Re: Permit Number:	PLN50177 SPR
Applicant:	TSENG Properties, LLC PO Box 11765 Bainbridge Island, WA 98110
Project:	Creative Space Site Plan and Design Review

Staff Report

Project: Creative Space Site Plan and Design Review

File Number: PLN50177SPR

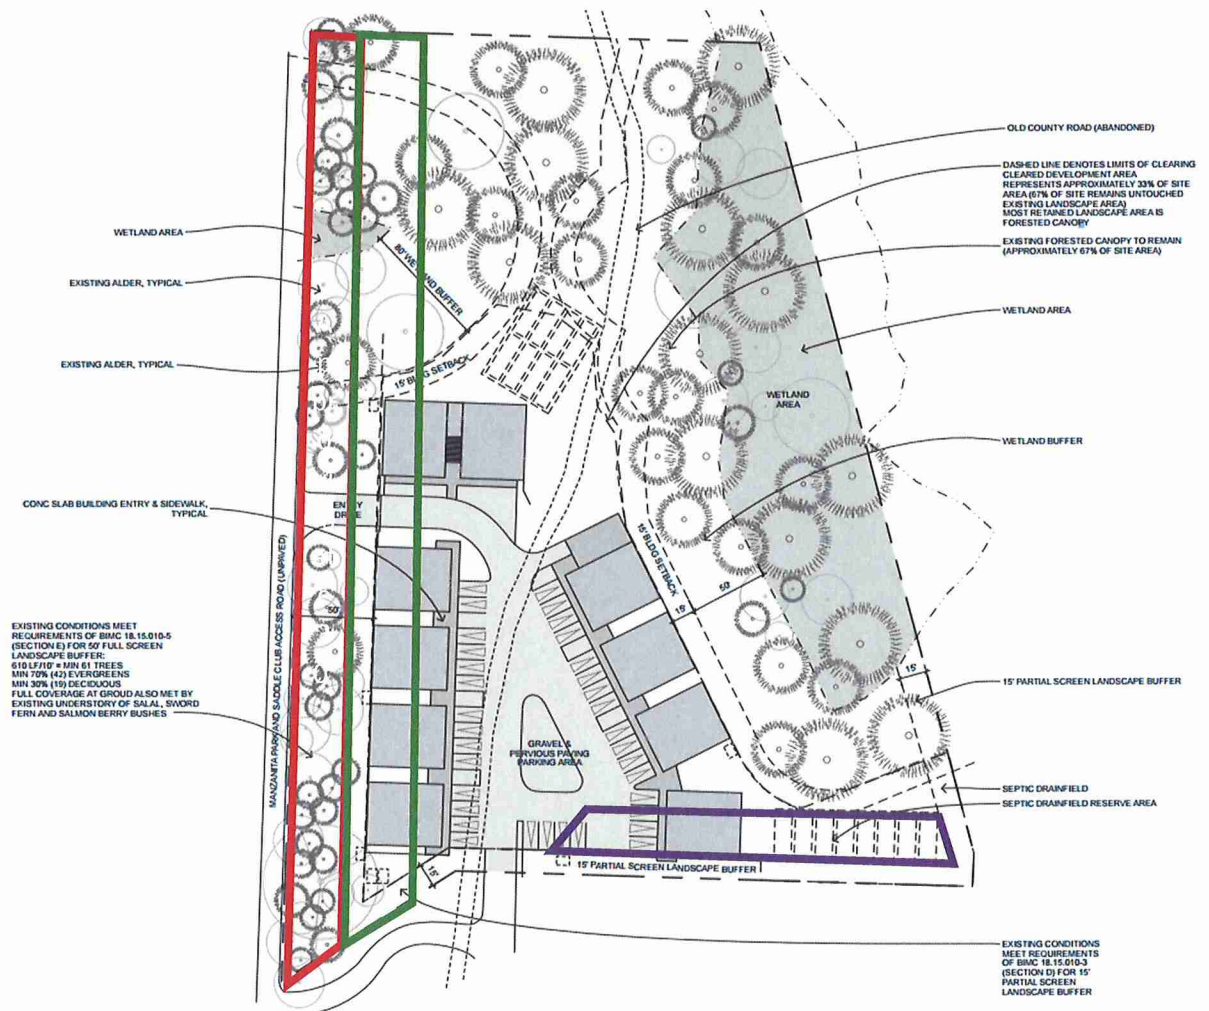
The property abuts a private road that is shared with the Saddle Club. The road is accessible with a 60' access easement, 30' of which are on the subject property. Thirty feet east of the road is an easement that has been left in its vegetative state. As part of the project, the intention is to leave this easement in its vegetative state, except to enhance it with a trail for pedestrians and horses. Five of the western most buildings are proposed within the 50' perimeter landscape buffer. The 50' landscape buffer was adopted through Ordinance 2016-1. Previously, it had been 30'. Since the ordinance was adopted on March 22, 2016, which was after this application had been filed with the City and approved by the Design Review Board, the application must be reviewed under the requirements of the 30' landscape buffer. For a more detailed explanation of the applicant's position, please refer to the April 17, 2017, letter submitted by the applicant's counsel to the City. A second 50' access and utility easement exists on the southern border of the property, running east/west. The applicant is proposing to include within that easement area one of the buildings, a landscaping buffer, parking, and drainfields. This easement wasn't included in the applicant's proposed site plans. In researching the site, the City discovered the easement and informed the applicant about the existence of the easement. When so informed by the City, the applicant responded by indicating that they would vacate the easement, without specifying how this would be accomplished (reference doc 19). Certain members of the applicant own and control the company that has the legal rights to the easement. As such, they are in the position to extinguish it. Moreover, approval of the application can be made subject to the extinguishment of the easement.

The property has two wetlands and associated buffers. The site plan does not propose any encroachments into the wetlands and their buffers (reference doc 6). However, stormwater is proposed to discharge to a wetland at the outfall of a replaced culvert proposed to be located opposite the access point along Saddle Club road. The applicant was asked to address the potential impacts on the wetland. This information has not been provided to the City. The applicant's civil engineer, Adam Wheeler, did submit a response to the City's concern, which addressed it. If there are further concerns, approval can be made subject to addressing the concerns.

In the preparation of this staff report, comments were received from the City's surveyor regarding the 30' easement on the property. While reviewing the easement, the surveyor also noted a 50' access and utilities easement on the south side of the subject property. This easement was not depicted on any of the drawings submitted by the applicant. The 50' easement was established in 1991 and was to serve the southern lot and the adjoining lot to the east. The site plan depicts development in this easement area. The City cannot approve the proposed development as depicted because it would impede ingress and egress access to the adjoining property. The project site plan proposes a building, landscaping, a drainfield, and parking within the access easement, which would violate the rights of the easement holder without consent of the current easement holder to abandon this easement. **Again, approval of the application can be made contingent on the applicant obtaining consent from the current easement holder to abandon this easement.**
